**CHANDIGARH
HOUSING BOARD**
A CHANDIGARH ADMINISTRATION UNDERTAKING

No.CHB/EO/DY.EO-I/2022/ 4051

Subject : Additional construction / violations in Duplex Flats in Sector 41-A, Chandigarh.

H.No. 673/1, SEC. 41A

FIRST FLOOR PLAN

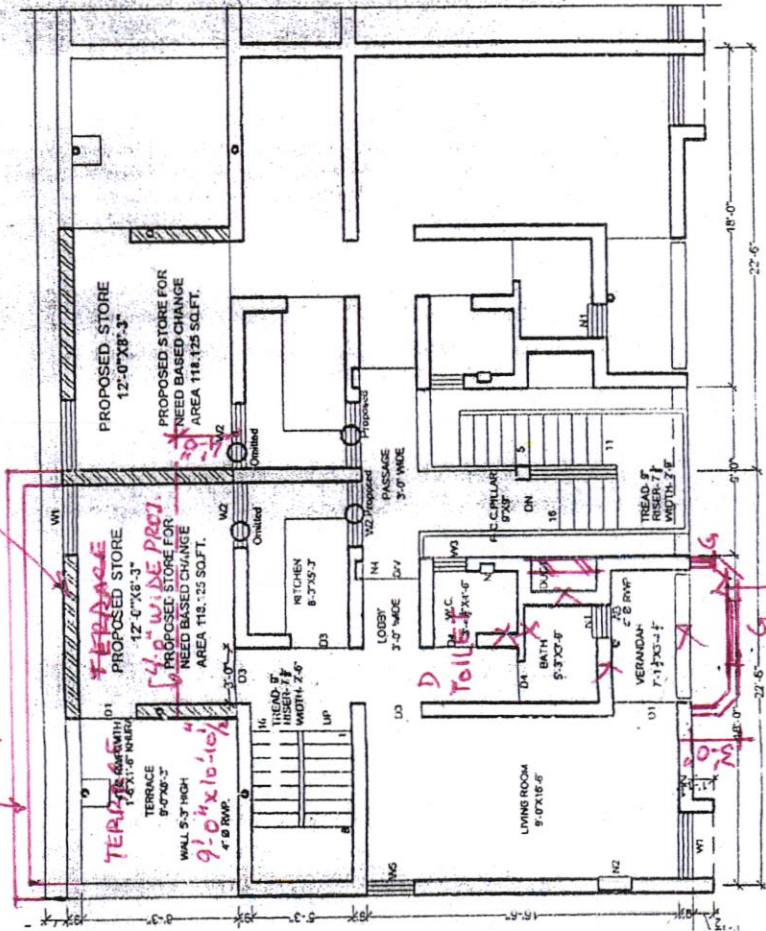
SHED WITH ASBESTUS SHEET

Parapet 5'-3" HIGH

RCC ROOF AT 6.9" HT.

SECOND FLOOR PLAN

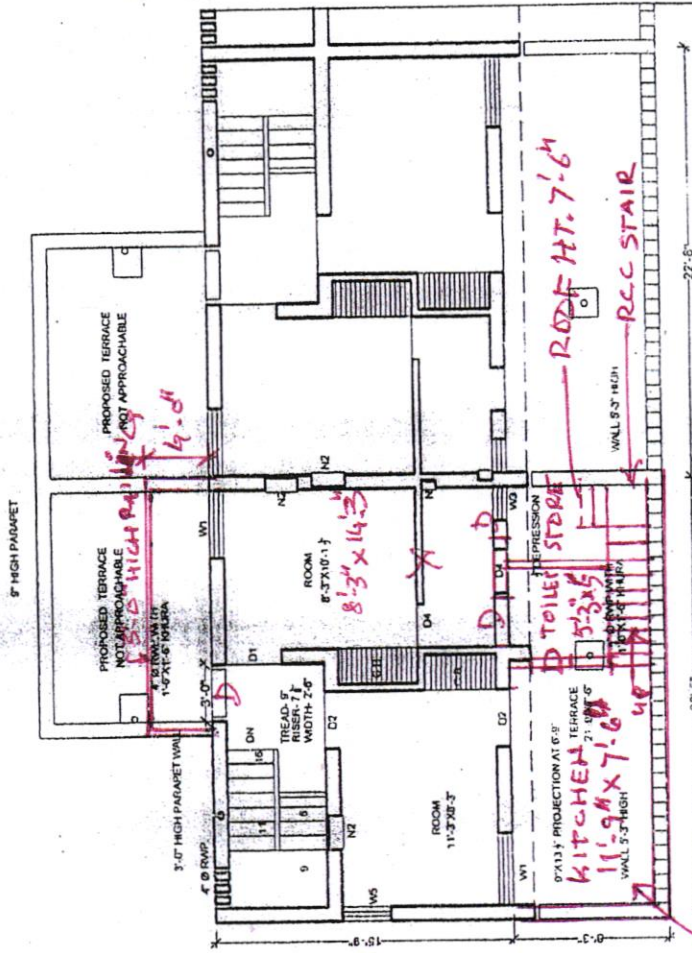
Additional room at first floor is not

As such, you are advised to remove / set right the violations as per standard drawing of CHB to ensure the structural stability / safety **within 30 days** positively under intimation to this office along with Structure Stability Certificate issued by the empanelled Structural Engineer by Chandigarh Administration, failing which the action will be taken by CHB as per rules / policy and as per the directions of Hon'ble High Court.
